From: [Ruby Phillips](#)
To: [Alvin Jen](#)
Subject: FW: Notice of Availability SEIR - Ravenswood Business District/4 Corners Specific Plan Update, City of East Palo Alto
Date: Friday, July 26, 2024 1:14:25 PM
Attachments: [image001.png](#)
[Outlook-hempmyby.png](#)

Subject: Notice of Availability SEIR - Ravenswood Business District/4 Corners Specific Plan Update, City of East Palo Alto

The City of East Palo Alto, as the Lead Agency, prepared a Subsequent Environmental Impact Report (SEIR) in accordance with the California Environmental Act (CEQA) for the Ravenswood Business District/4 Corners Specific Plan Update. Please see the attached document in English and Spanish for more details.

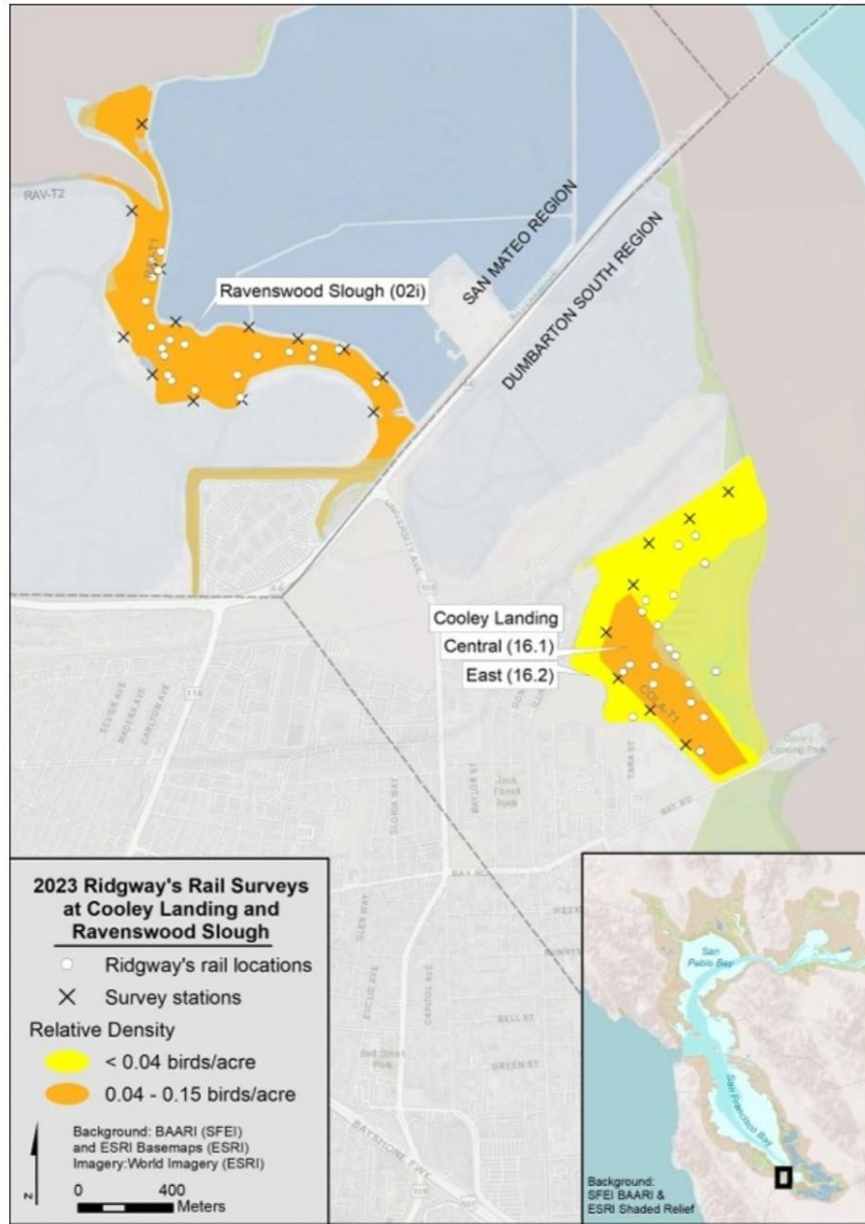
"Occurrence in Ravenswood/4 Corners": This table identifies lands within the RBD Area and adjoining the northeast part of the project that are known habitat for California Ridgway's rails (RIRA).

Recommendation: *Please also describe marshes between Cooley Landing and Runnymede Street, the Laumeister Marsh, a unit of the Don Edwards National Wildlife Refuge. 2023 survey report data maps a substantial number of these rails in the Ravenswood Open Space Preserve.⁹ Like surveys were not performed in the Refuge's Laumeister Marsh for that report but, by proximity and historical surveys, it is highly likely that Ridgway's rails use that marsh as well.*

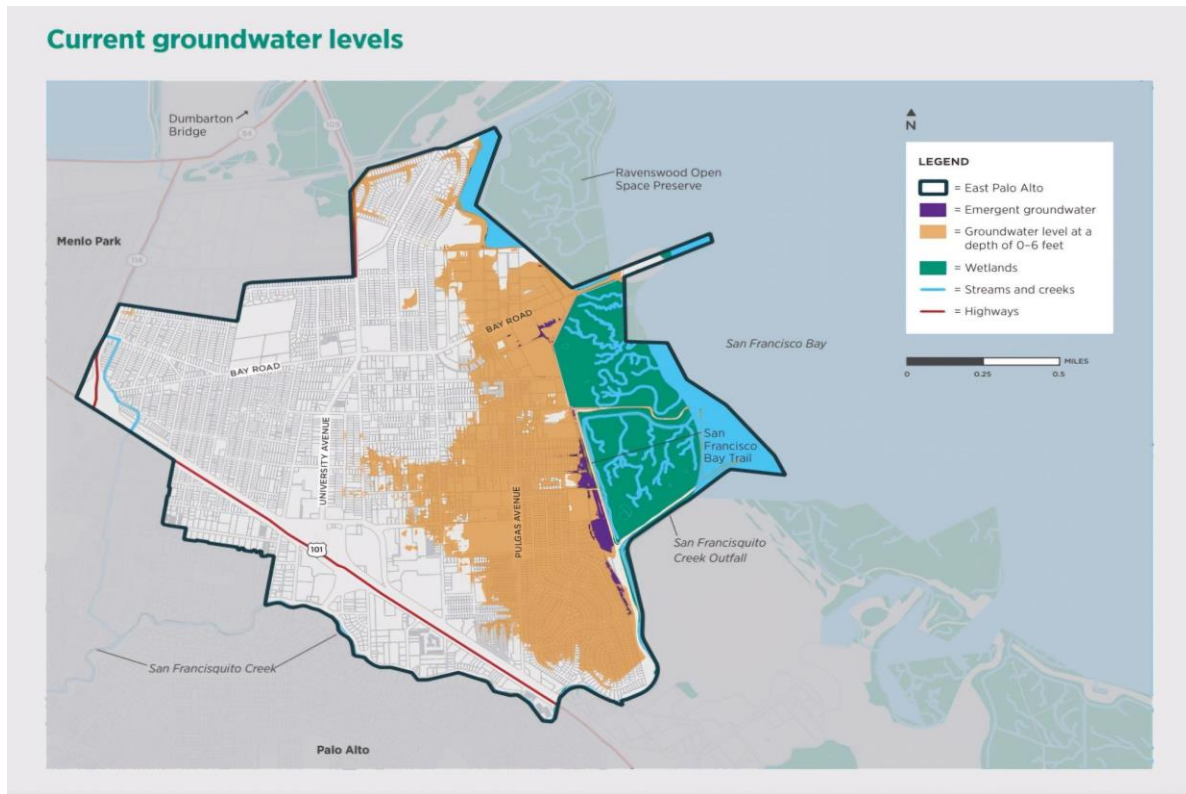
Section 3.10 Groundwater discussion focuses on recharge of groundwater and notes that historical groundwater levels vary from zero to 10 feet below existing grade, citing California Geological Survey data from 2006. The discussion omits more recent data such as was the

basis for the report, Look Out Below,³² a case study built on recent, substantial, and local scientific studies³³ that provided data specific to East Palo Alto. In it, maps displayed large areas of East Palo Alto and the SP Area with groundwater levels either at zero to six feet below grade or emergent. These areas lay along the shoreline, extend substantially inland and have underground flow adjacency with non-SPU areas. The Look Out Below map seen here includes an isolated zero to six feet site along University Avenue near 4 Corners.

While 9.7-6, as proposed, is limited to shoreline properties, recent data demonstrate that shallow groundwater impacts apply much more broadly in the SP Area. As shallow groundwater areas connect across project and Specific Plan boundaries, a development action in one location, such as a below-ground garage, can redirect subsurface water onto other parcels or the Bay, impacting conditions on those sites.

Recommendation: *DSPU Standard 9.7.6 should be amended to apply area-wide and flooding should be added to the impacts articulated in the Standard. Additionally, like DSPU Policy LU-6.4, Standard 9.7.6 should be incorporated throughout the SEIR's Land Use and Planning Impact Discussion, Section 3.11.2, and Non-CEQA Effects discussion, Section 3.11.3.*

Figure 5

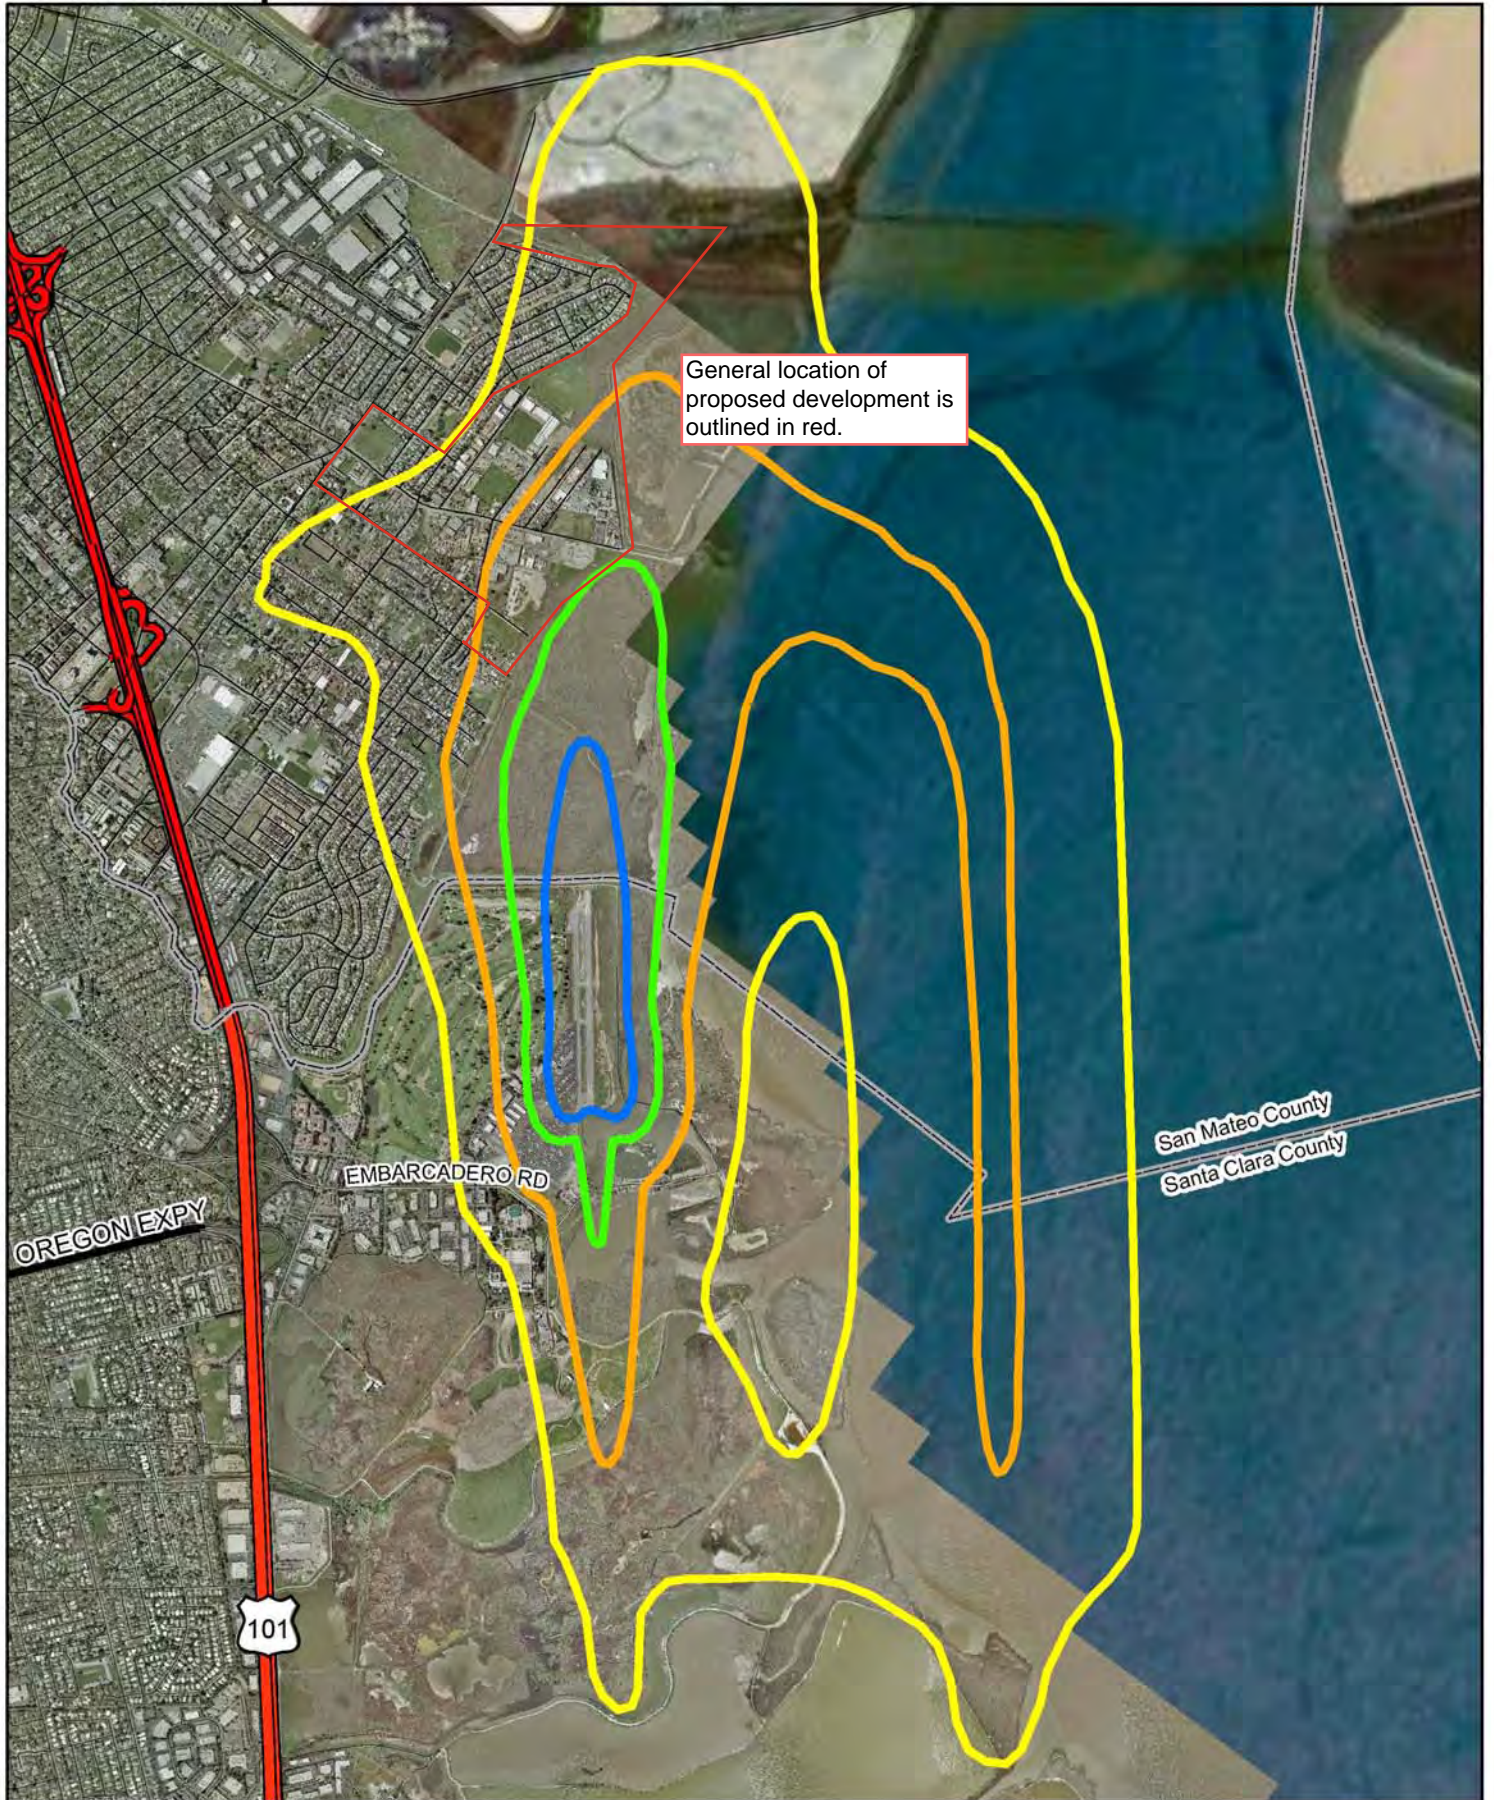
- In reviewing Figures 2.3.1 (proposed land uses) and 2.3.2 (existing land uses) of the Draft EIR, the project proposes to increase residential uses/density within the 60 and 65 CNEL contours of the Palo Alto Airport Influence Area. The Draft EIR does not properly disclose, and therefore does not identify appropriate mitigation, to address impacts related to the development of residential uses within the AIA and specifically within these contours, consistent with the policies set forth in the Palo Alto Airport Comprehensive Land Use Plan (CLUP). Please refer to the attached CLUP Figure 5 for the airports' Aircraft Noise Contours.

- *N-5 Residential construction will not be permitted in the area between the 60 dB CNEL contour boundary and the 65 dB CNEL contour boundary unless it can be demonstrated that the resulting interior sound level will be no greater than 45 dB CNEL.*

Due to the proximity of the Plan area to the Palo Alto Airport, the SEIR should anticipate that future residents will experience aircraft noise in the area. To prevent this project from expanding the airport's noise impact area, each residential unit shall grant the airport an aviation easement, permitting aircraft noise over the property.
